LOT GRADING PLAN'S APPROVED
SUBJECT TO REVISIONS NOTED

DRAWN BY	AO	SCALE	1:250	PROJECT No.	09014	LOT NUMBER	9
----------	----	-------	-------	-------------	-------	------------	---

CLIENT	ZANCOR HOMES
PROJECT/LOCATION	OLDE WINCHESTER BROOKLIN, ONT
DRAWING	SITE GRADING PLAN

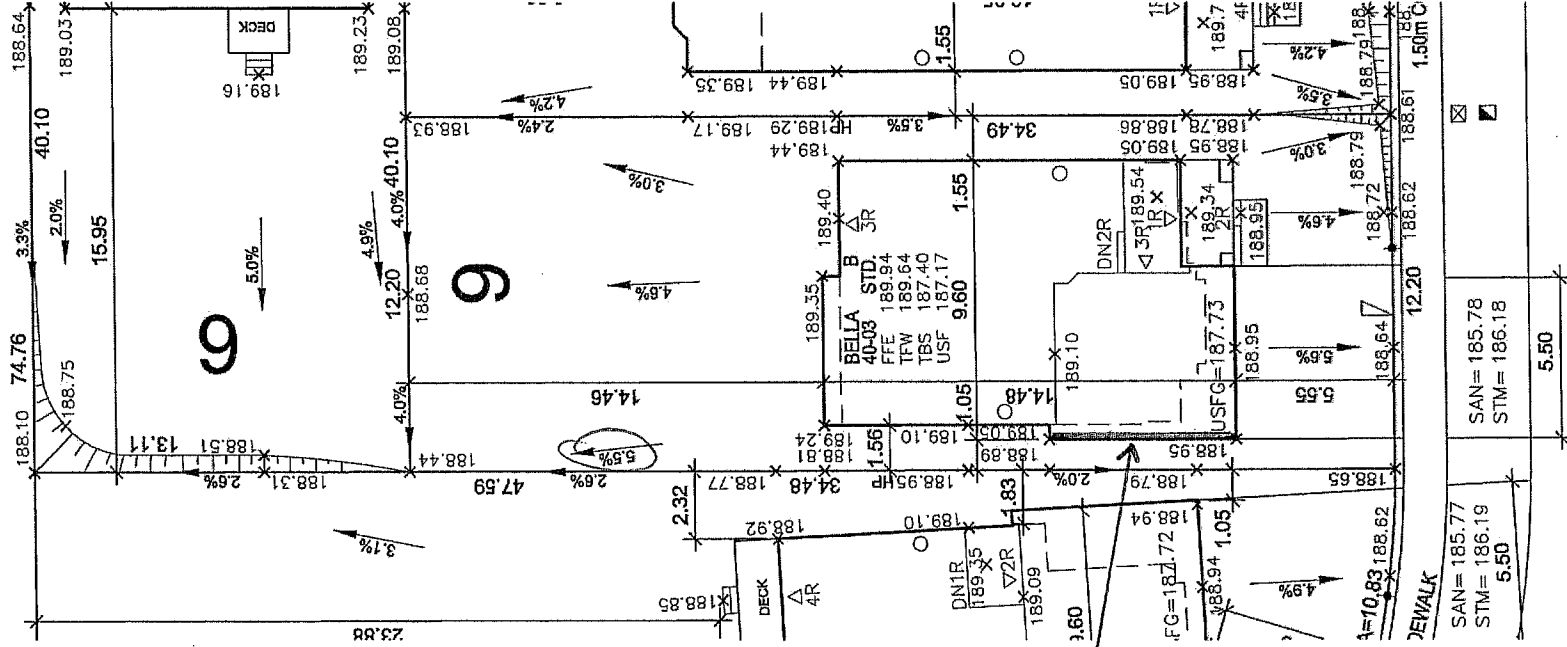
NOTE:
Provide minimum 45 minute
fire-resistant partition to
exposed building face as
prescribed by 9.10.15.5.(2)(b)
